VERIFICATION REPORT “SKHIDENERGO” LTD.

VERIFICATION OF THE **RECONSTRUCTION OF UNITS 1, 2, 3 AND 4 AT ZUYEVSKA THERMAL POWER PLANT.**

REPORT No. UKRAINE-VER/0148/2010

Figure 1: Data collection and processing for monitoring at Zuyevska TPP

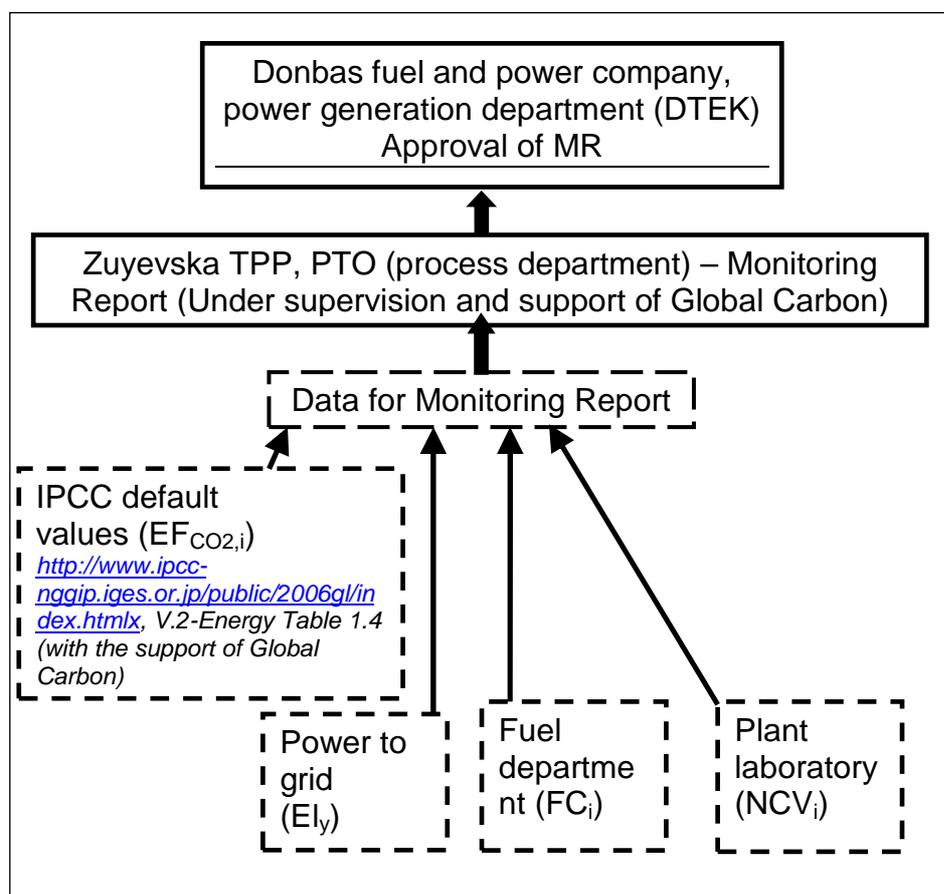
DVM Paragraph	Check Item	Initial finding	Action requested to project participants	Review of project Participants' action	Conclusion
		<p>parameters.</p> <p>CAR5: PTO department but not process department collected and archived necessary data.</p> <p>CL4: Please clarify in MR (Figure 2: Data collection and processing for monitoring at Zuyevska TPP) what MP means.</p> <p>CAR6: Global Carbon but not DTEK or station staff collected IPCC data. Please explain and correct this.</p>	<p>CAR5: corrected in MR version 2.0.</p> <p>CL4: Misprint MP has been corrected to Monitoring Report in MR ver2.0. More detailed chart is provided.</p> <p>CAR 6: Corrected in Figure 2 in MR ver2.0. Role of Global Carbon is described.</p>	<p>The issue is closed.</p> <p>The issue is closed.</p> <p>The issue is closed.</p>	
95 (a)	For calculating the emission reductions or enhancements of net removals, were key factors, e.g. those listed in 23 (b) (i)-	CL5: Please mention and describe 3-TECH	CL5: Purpose and brief content of 3-TECH reporting form is provided	The issue is closed.	OK
